**Report to the Future Melbourne (Planning) Committee**

**Ministerial Planning Referral: TPD-2010-9/C  
695-699 La Trobe Street, Docklands**

**19 March 2019**

## DELEGATE PLANNING REPORT

1 HARBOUR ESPLANADE STREET ELEVATION (WEST)  
SCALE 1:50@A0

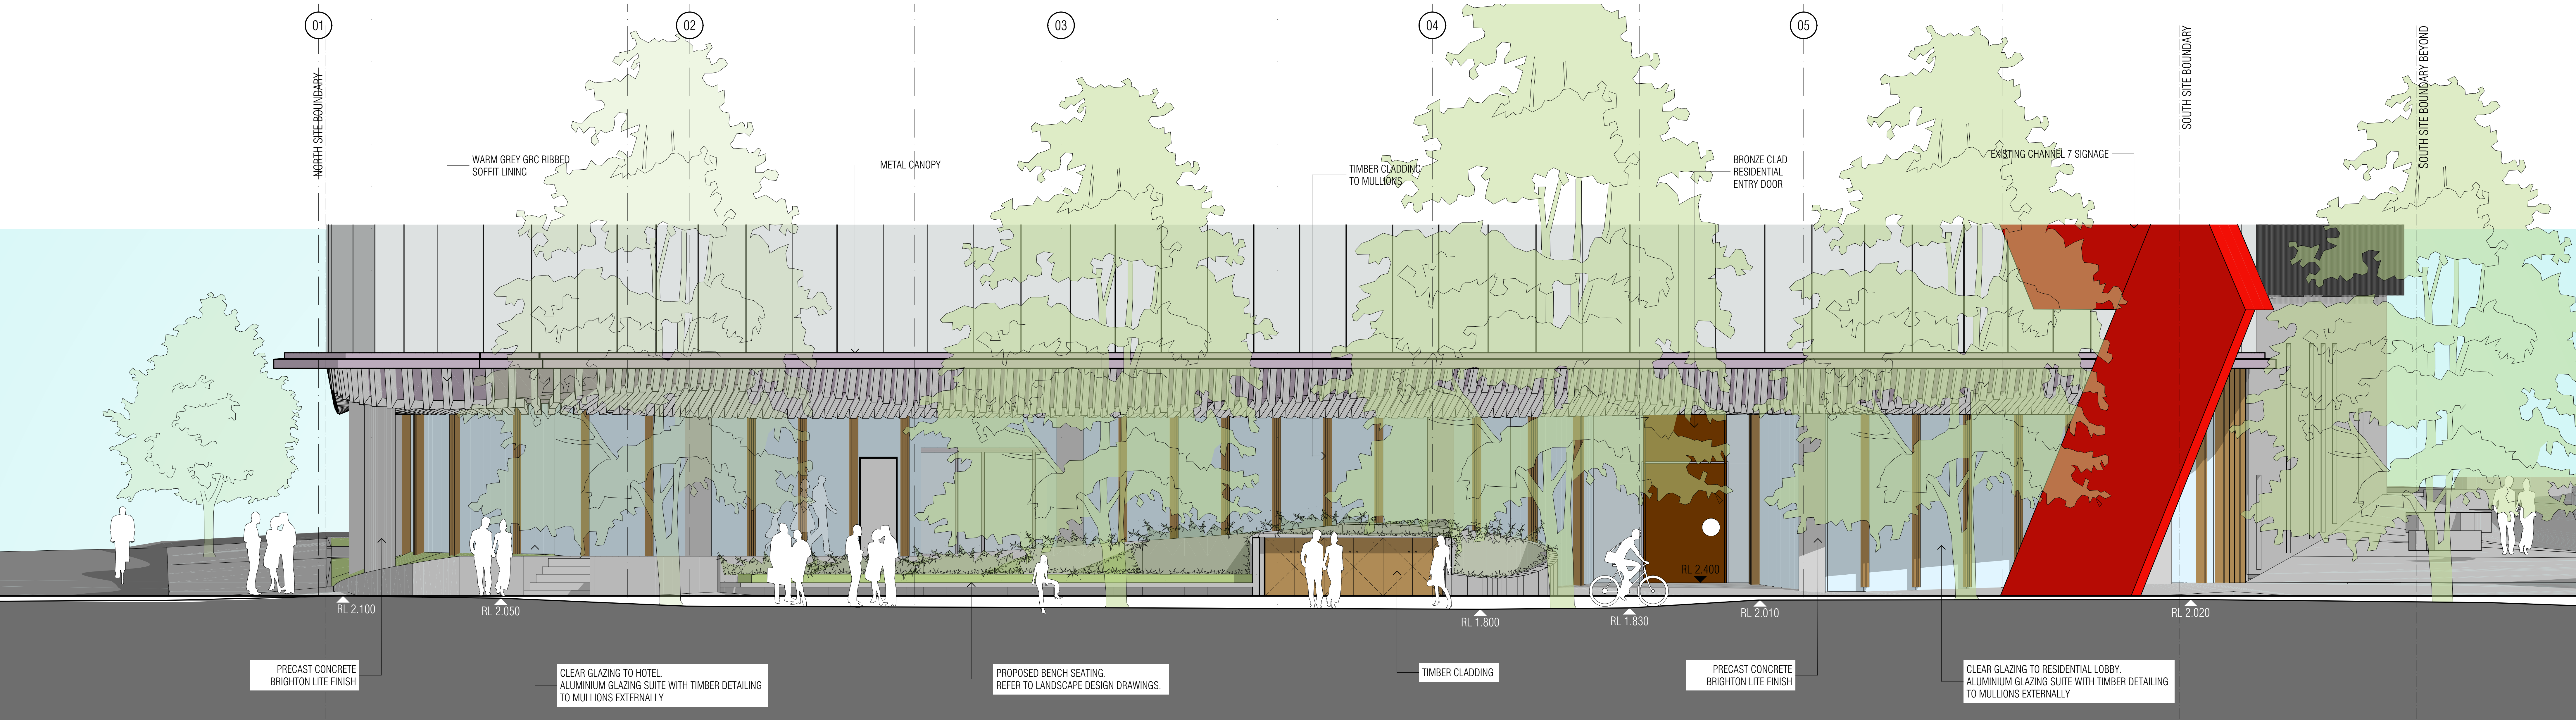
5. The key issue for consideration is the impact of the proposed external alterations on the streetscape and built form character, particularly the visual bulk of the development when viewed from Harbour Esplanade and Victoria Harbour.

6. Although the tower still steps down in height, the loss of the rectilinear form replaced by a proposed curved glass mass results in unacceptable visual bulk particularly when viewed from Harbour Esplanade. The changes recommended by Urban Design are reflected in the most recently submitted façade design and will increase articulation of the tower, thereby reducing visual bulk.

Urban Design has raised concerns with the proposal throughout the amendment process, primarily regarding the foyer resolution at ground level, vehicle dominance of the porte-cochere, level changes to Harbour Esplanade and a lack of legitimate podium and division of upper form resulting in bulk and visual impact to Harbour Esplanade.

- a) The public footpath along Harbour Esplanade must be widened to align with the footpath width generally provided on the east side of Harbour Esplanade such as north of La Trobe Street and from the Stadium to Bourke Street.

Figure 1 – Elevational comparison between the two facades

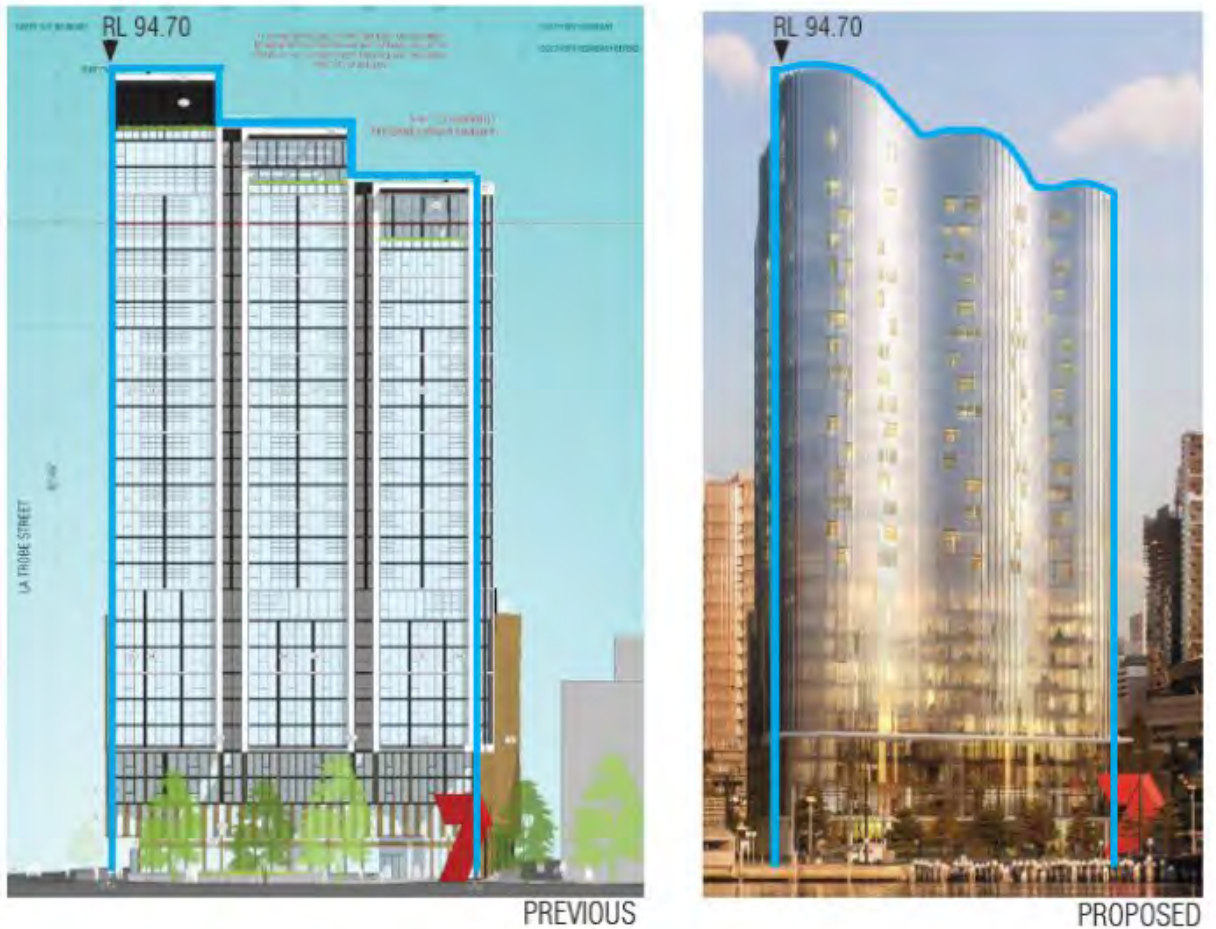
The proposal seeks to introduce a curved glass wall across the entire façade, resulting in a more gradual transition in height and reduced differentiation between the three tower elements. See comparison images below:

While the tower maintains a transition in height, the change to a curved glass facade has resulted in a loss of the three 'tower' rectilinear forms with each vertical element being clearly distinguishable.

Urban Design has raised concerns with the reduced separation between the podium and tower and the impact of the visual bulk of the proposed curved glass wall when viewed from the west. Ongoing discussions with DELWP, the City of Melbourne and the applicant have resulted in a revised concept being submitted for review. This design response has not been formally submitted and would need to be conditioned as part of any permit issued.

The changes suggested by Urban Design are reflected in the above plans and increase the articulation of the tower, thereby reducing visual bulk, particularly when viewed from Harbour Esplanade. The draft response provides greater texture and gradient to the podium and tower forms through mullion / fins which accentuate the curved form and provide a gradient of detail down to the public realm (in lieu of a podium).

This design is the preferred option however it has not been formally submitted and would need to be conditioned, including a requirement to provide further detail and texture to the lower levels as part of any permit issued. Subject to the application of detailed timber fins, the proposal will make a positive contribution to the character and quality of the waterfront place, as sought by Clause 22.18. The use of timber
